F6 Extension Stage 1

New M5 Motorway at Arncliffe to
President Avenue at Kogarah

Preferred infrastructure report

Figure 2-2 Proposed changes to access at Moorefield Estate

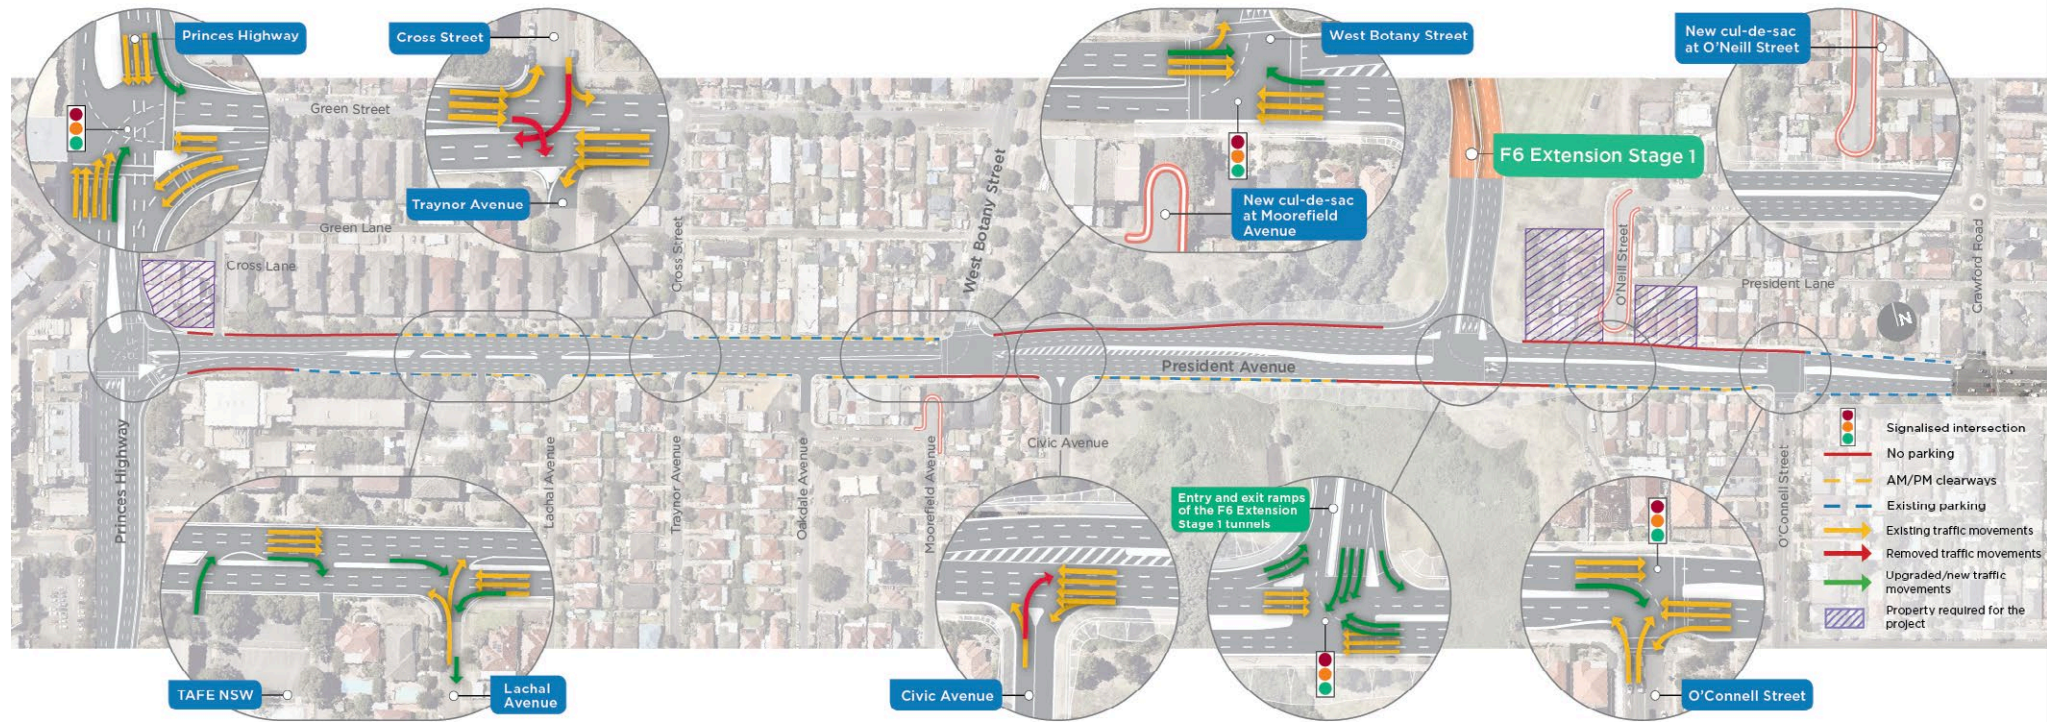
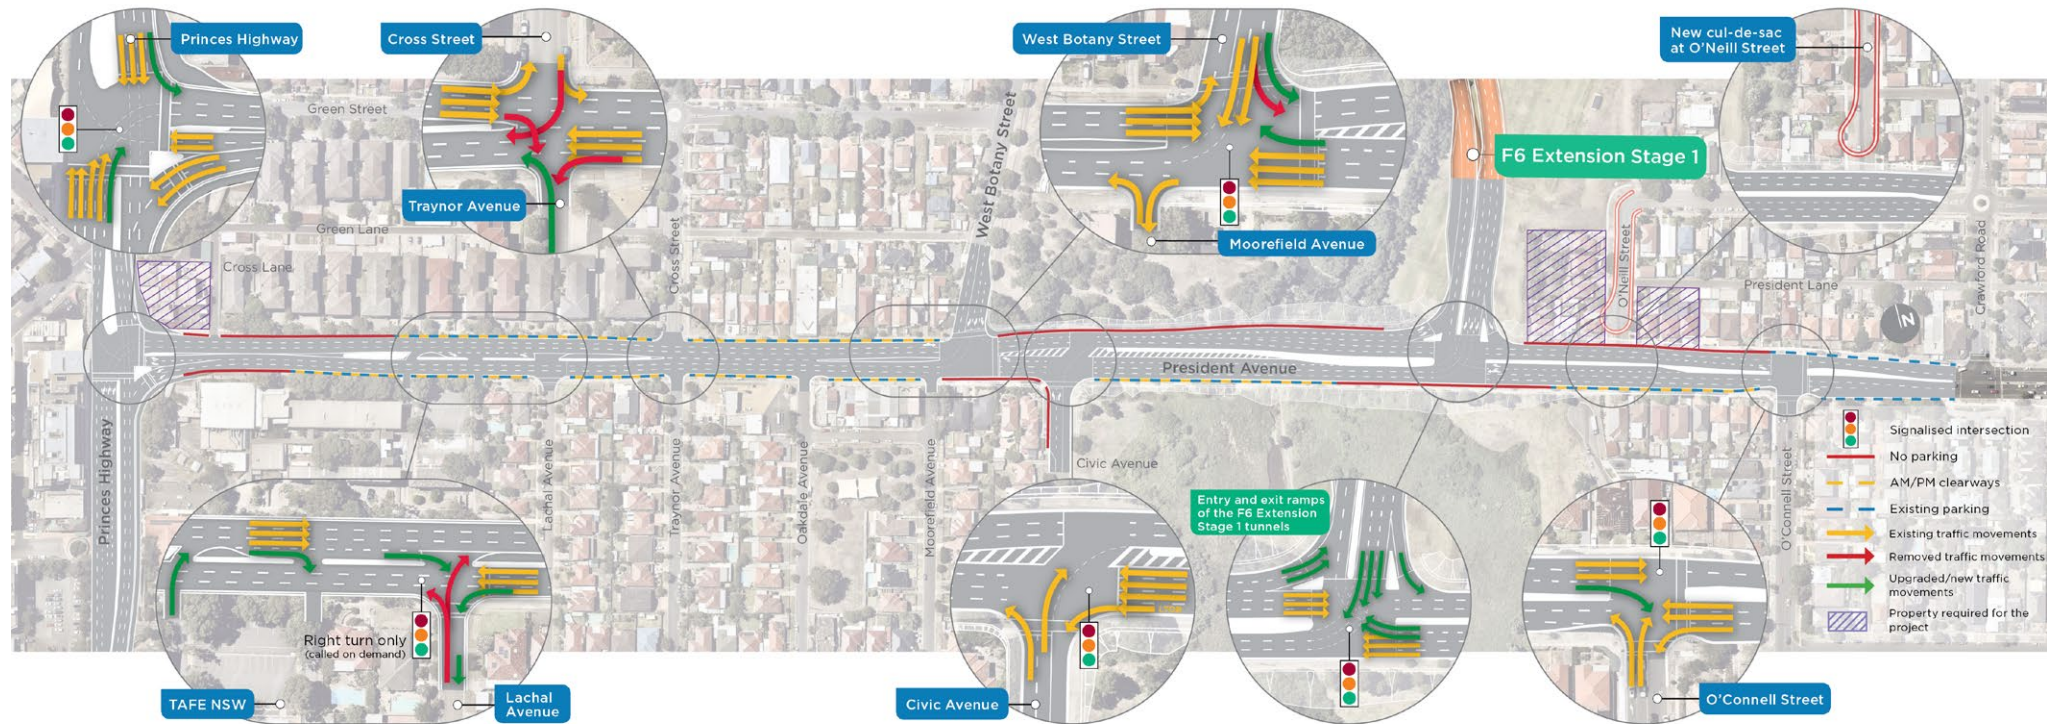
The following key changes are proposed to the access arrangements at President Avenue:

- Lachal Avenue would be converted from one-way northbound to one-way southbound (inbound movements from President Avenue only). A right turn bay and traffic signals would be provided for the right turn into Lachal Avenue from President Avenue, to ensure safe vehicle movements. A pedestrian crossing would be provided across Lachal Avenue

- Traynor Avenue would be converted from one-way southbound to one-way northbound. Only left turn movements out of President Avenue would be permitted. This change would allow Lachal Avenue and Traynor Avenue to continue to operate as a one-way pair

- The cul-de-sac at Moorefield Avenue, as described in the EIS, would not proceed. Following a review of demand, it was determined that Moorefield Avenue could remain open in its existing arrangement as a left in, left out intersection

- An additional 60 metre southbound left turn bay at the existing signalised intersection at West Botany Street and President Avenue would be provided
- A signalised intersection would be provided to allow for safer right turn movements from Civic Avenue into President Avenue. Available traffic movements would remain the same as the existing network configuration, with no right turns permitted from President Avenue into Civic Avenue. The President Avenue/Civic Avenue and the President Avenue/West Botany Street

intersections would operate under one signal controller to allow better control of traffic movements at this section of the President Avenue corridor. A pedestrian crossing would be provided across Civic Avenue.

Road (at intersection with President Avenue)	Existing arrangement	EIS arrangement	Proposed arrangement	Justification for change
Lachal Avenue	One-way northbound (outbound movements to President Avenue only).	Lachal Avenue would be converted from one-way northbound to two-way. A right turn bay would be provided to formalise the right turn into Lachal Avenue from President Avenue, and to ensure safe vehicle movements. A refuge bay would be provided for the right turn out of Lachal Avenue onto President Avenue to ensure safe vehicle movements.	Lachal Avenue would be converted from one-way northbound to one-way southbound (inbound movements from President Avenue only). A right turn bay and traffic signals would be provided for the right turn into Lachal Avenue from President Avenue, to ensure safe vehicle movements. A pedestrian crossing would be provided across Lachal Avenue. The proposed arrangement means that on-street parking restrictions would not be required on Lachal Avenue, which would remain as a one-way street.	Provides a signalised right turn movement into the Moorefield Estate area, thereby reducing potential traffic conflicts. Maintaining one-way operation reduces impacts on Lachal Avenue.

Traynor Avenue	One-way southbound (inbound movements from President Avenue only). Left and right turn from President Avenue permitted.	Traynor Avenue would be retained as one-way southbound. Due to the right turn arrangements at Lachal Avenue, the right turn into Traynor Avenue would not be possible, but the left in movement would remain.	Traynor Avenue would be converted from one-way southbound to one-way northbound. Left turn out onto President Avenue only.	Allows Traynor Avenue and Lachal Avenue to operate as a one-way pair, with a right turn in movement allowed at Lachal Avenue. Safe right turn movements onto President Avenue can be made via the proposed signalised Civic Avenue intersection arrangement described below.
Oakdale Avenue	Two-way. All movements allowed.	No change to existing traffic movements.	No change to existing.	No change to existing.
Moorefield Avenue	Two-way. Left in and left out only.	Moorefield Avenue would be converted to a cul-de-sac at President Avenue to relocate movements to a safer location for vehicles as they turn in or out of the upgraded President Avenue.	No change to existing. Two-way. Left in and left out only.	Based on the surveyed and forecast traffic volumes using this intersection, it was determined that it could remain open and not require a cul-de-sac.

West Botany Street	Signalised intersection.	No change to existing traffic movements.	Provision of an additional 60 metre southbound left turn bay at the existing signalised intersection	Reduces the forecast queue length on the West Botany Street approach.

Figure 3-1 Alignment of the proposed shared cycle and pedestrian pathways for the project

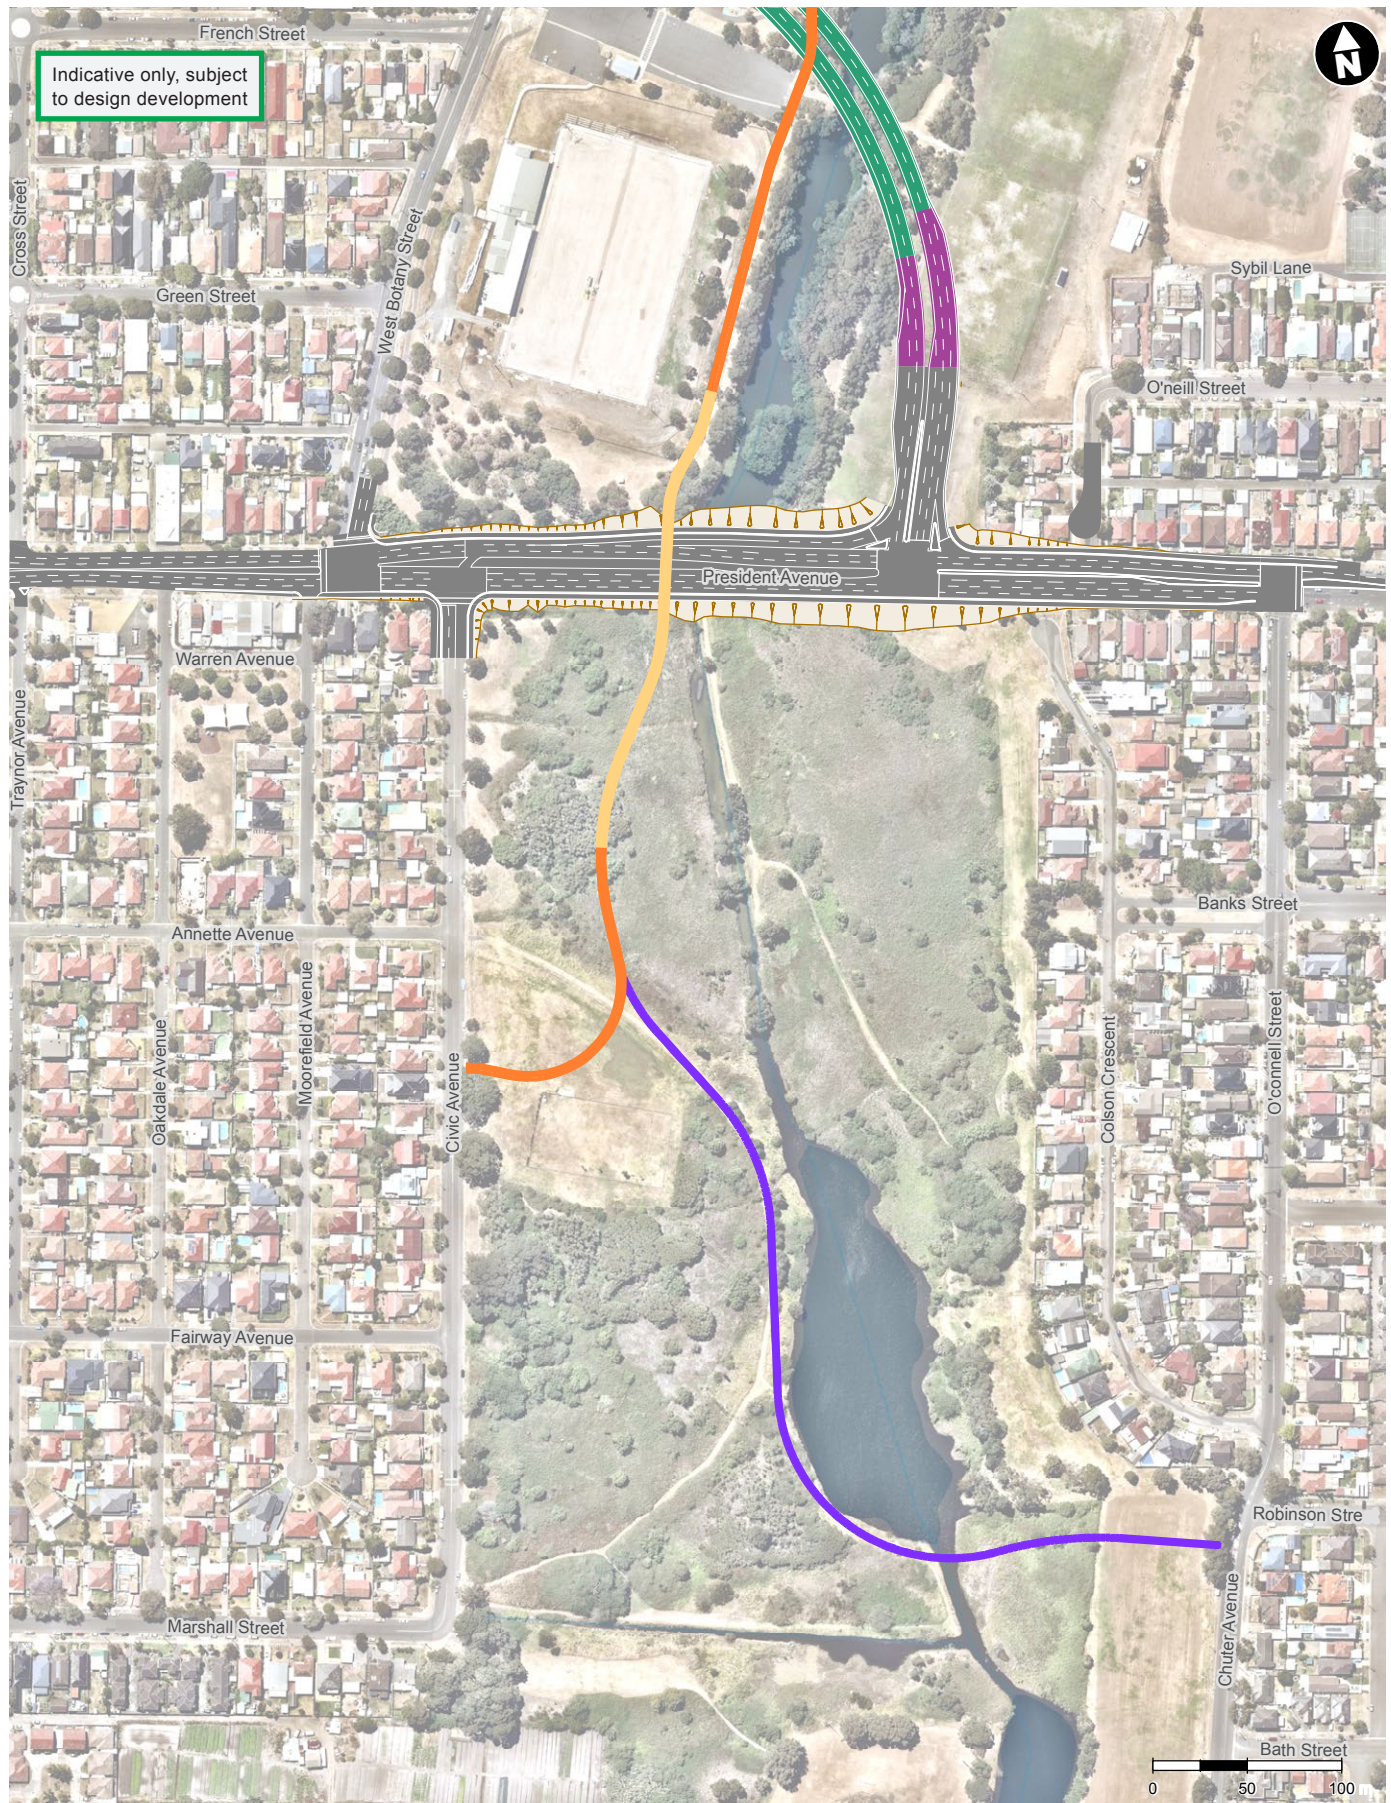
The shared cycle and pedestrian pathways proposed in section 6.8 of the EIS would be extended from President Avenue through Scarborough Park North across to Chuter Avenue/O'Connell Street. The proposed extension would:

- Increase the shared cycle and pedestrian pathway proposed in the EIS by around 600 metres south from the connection to Civic Avenue
- Be constructed as a 3 metre wide boardwalk (or other low impact design) to minimise potential flooding impacts and would generally follow existing informal walking/access tracks within Scarborough Park
- Cross the watercourse in Scarborough Park via a steel bridge structure
- Include an upgraded pedestrian refuge at the connection point with the existing on road cycle network at Chuter Avenue/O'Connell Street, south of Robinson Street.

The section of the shared cycle and pedestrian pathway which links the pathway to the west towards Annette Avenue, would be retained. The proposed alignment and the original alignment presented in the EIS are shown in **Figure 3-1**.
